H. B. ROBINSON STEAM ELECTRIC PLANT, UNIT NO. 2
DOCKET NO. 50-261/LICENSE NO. DPR-23

TRANSMITTAL OF CORE OPERATING LIMITS REPORT

CYCLE 27 CORE OPERATING LIMITS REPORT, REVISION 0

SUMMARY OF CHANGES
PRR 360766
FMP-001

Figure 5.0, Shutdown Margin Versus Boron Concentration

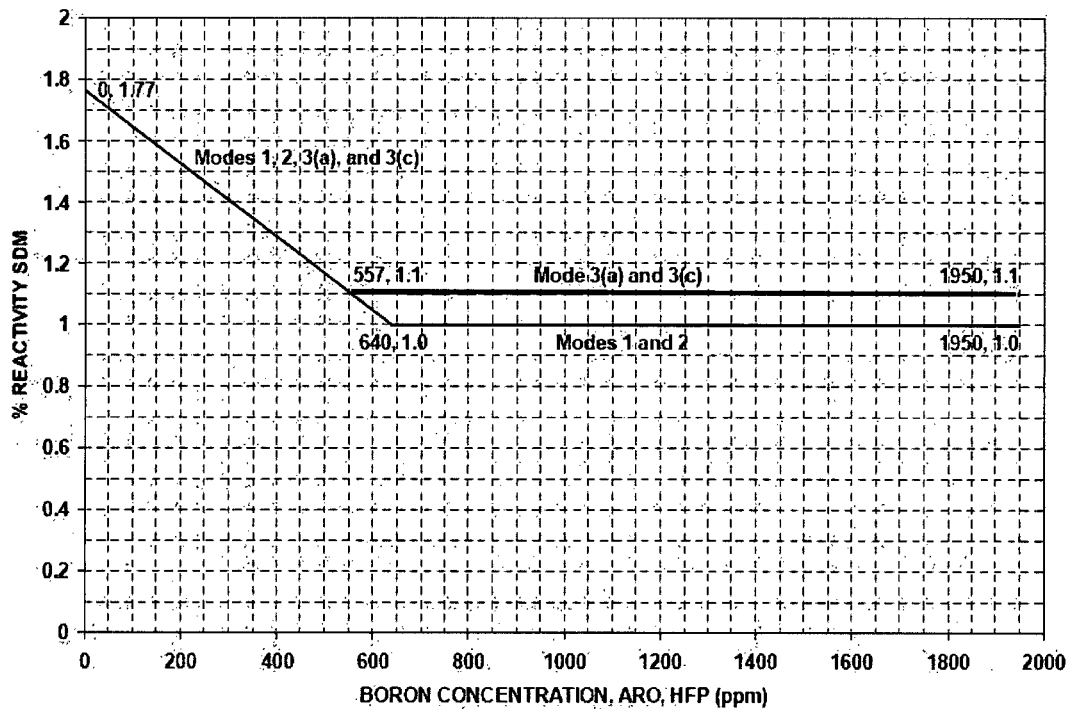
REVISION #	REVISION COMMENTS
26	<p>Per EC 72149</p> <ol style="list-style-type: none"> 1. Changed procedure revision numbering to "Revision 26" 2. Changed "Cycle 26" to "Cycle 27" throughout 3. Deleted Revision 25 Summary of Changes and added Revision 26 Summary of Changes 4. Changed Reference 2.5 to refer to the Cycle 27 Reload EC, EC 72149 5. Changed Reference 2.11 to refer to RNP-F/NFSA-0173 as the source of the markup 6. Add HBRSEP, ARO, NRC, RES and SDM to Section 8.2 Abbreviations. 7. Corrected run-on sentence in Section 8.3.2 by adding a period after "NRC" and starting a new sentence with "Hence". 8. Replaced "EC 66470" with "EC 72149" 9. Added statement "and is applicable to 490 EFPD (17,161 MWD/MTU)" to Attachment 10.1 Section 1.0 Operating Limits Report. 10. MTC Surveillance Limit for 300 and 60 ppm becomes -37.09 pcm/°F and -41.47 pcm/°F, respectively 11. Revised CFQ and FDH RTP limits to refer to ROB-19, ROB2-25, ROB2-26 and ROB2-27. 12. Modes 4(a), 4(c) and 5 revised from "4% $\Delta k/k$" to "2.6% $\Delta k/k$". 13. Attachment 10.1 Page 7 of 12 Note regarding breakpoint between BOL and EOL RIL updated from "257 EFPDs (9000 MWD/MTU)" to "243 EFPDs (8500 MWD/MTU)." 14. Changed the EOC burnup in Figure 3.1 Note from "18,275 MWD/MTU" to "17,161 MWD/MTU". 15. Corrected Attachment 10.1 Page Numbering where Page 20 of 24 in the procedure should have header stating "Page 9 of 12" 16. Replaced Figure 5.0 Shutdown Margin Versus Boron Concentration with new figure containing a line for the Modes 3(a) and 3(c) shutdown margin at (557, 1.1) to (1950, 1.1).
